**HARTZELL PROPELLER LLC**  
**ALERT SERVICE BULLETIN**  
**HC-ASB-61-406**  
**Counterweight Mounting Bolt Replacement**

## Counterweight Mounting Bolt Replacement

- (1) Hartzell Propeller has received reports of counterweight separations caused by failures of the A-2036-( ) cap screws used to attach the counterweights to the counterweight clamps on affected propellers.
  - (a) Hartzell Propeller has replaced the A-2036-( ) cap screws with 107995-( ) 12-point bolts on affected propellers manufactured after May 29, 2020.

**Counterweight Mounting Bolt Inspection**  
**Figure 1**

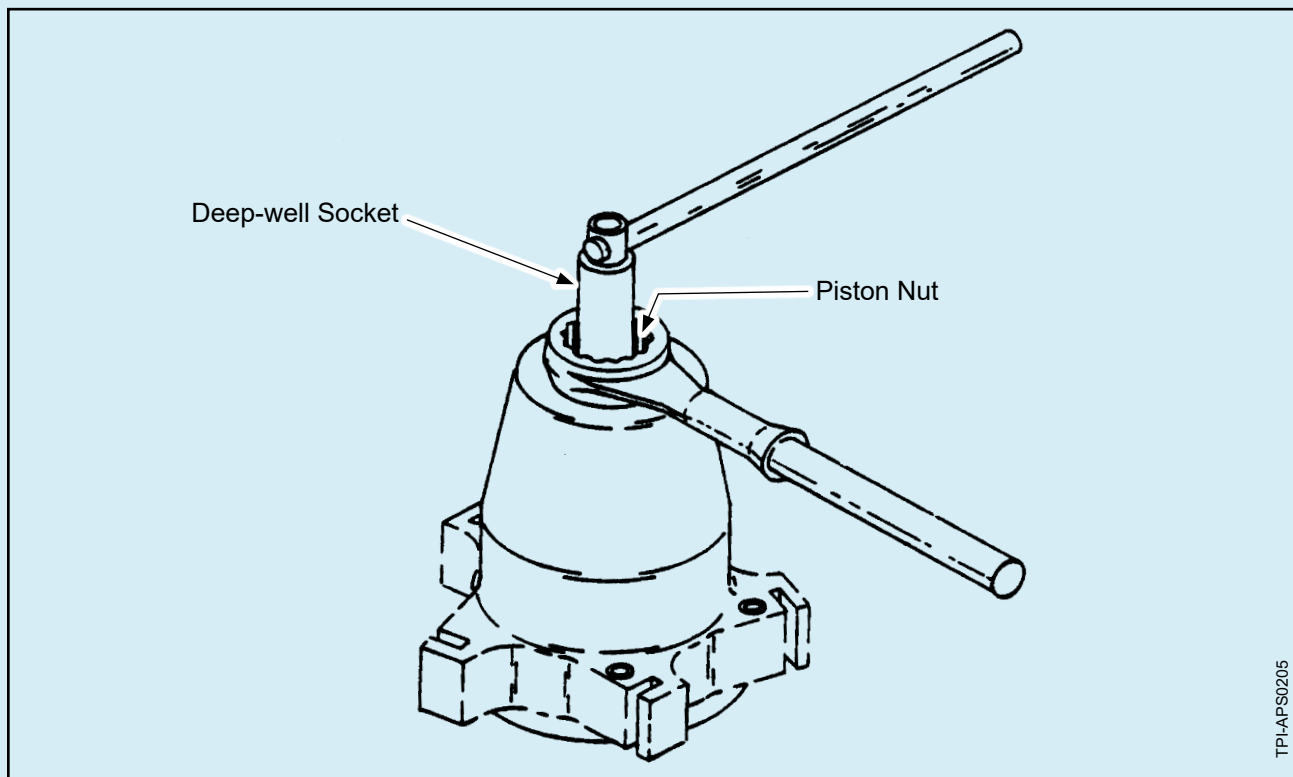
- (1) Remove the spinner dome in accordance with the applicable Hartzell Propeller Owner's Manual.
- (2) Visually examine the counterweight mounting bolts to determine the part number of the hardware used on the affected propeller. Refer to Figure 1.

- (a) If A-2036-( ) cap screws are used:
    - 1 Complete and sign the Parts Order/Compliance Form in the Appendix section of this Alert Service Bulletin.

- a Send the completed form to Hartzell Propeller to initiate the order for the required parts.
    - 2 Replace all A-2036-( ) cap screws with 107995-( ) 12-point bolts in accordance with the Counterweight Mounting Bolt Replacement procedure in this section.

- (b) If 107995-( ) 12-point bolts are used:
    - 1 No further action is required.
    - 2 Install the spinner dome in accordance with the applicable Hartzell Propeller Owner's Manual.

**Safety Holes/Spring Pins**  
**Figure 3**

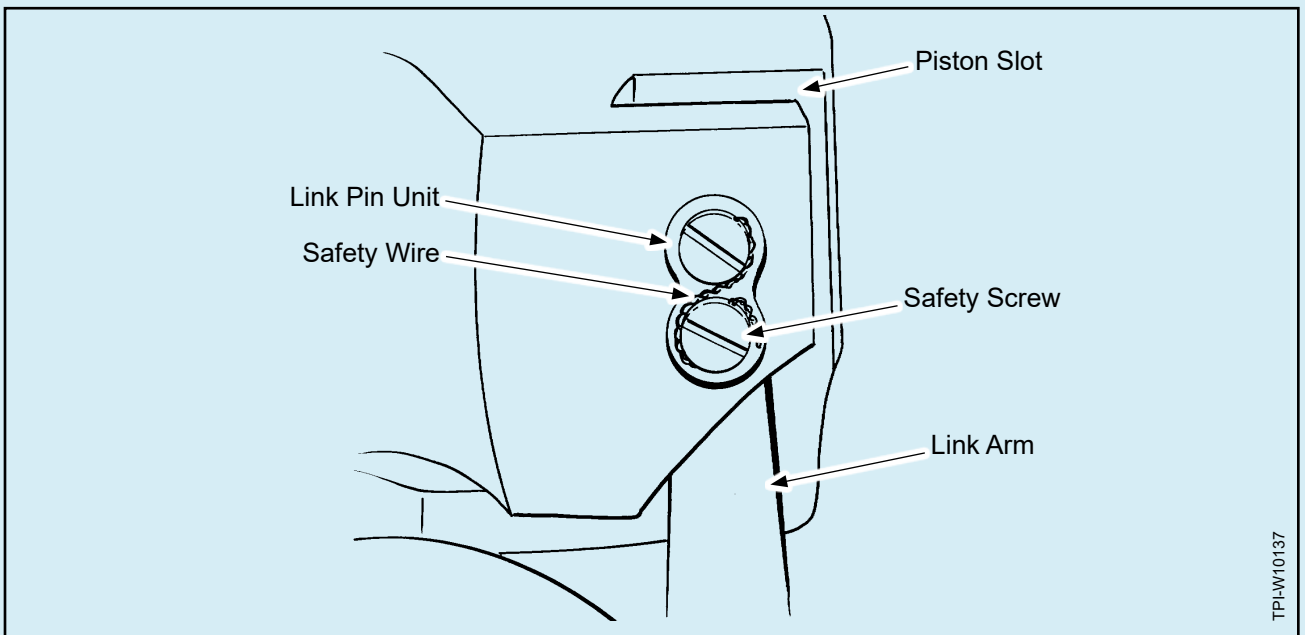
- (5) Remove and discard the spring pins (p/n A-285) that secure the A-2036-( ) cap screws to the counterweights. Refer to Figure 3.
  - (a) Using a punch, drive the spring pin inward, then remove and discard the pin.

- (8) Install one spring pin (p/n A-285) through each 107995-( ) 12-point bolt in accordance with Figure 3 and the following steps:
  - (a) Using a No. 42 drill bit (0.0935 inch dia.) through the safety hole in the counterweight, drill through the head of the 107995-( ) 12-point bolt.

- (b) Install a new spring pin (p/n A-285) through the safety hole until it is flush with the counterweight surface.
- (9) 3-blade Propeller Models Only: If two-piece counterweight slugs were removed, reinstall in accordance with Figure 5 and the following steps:
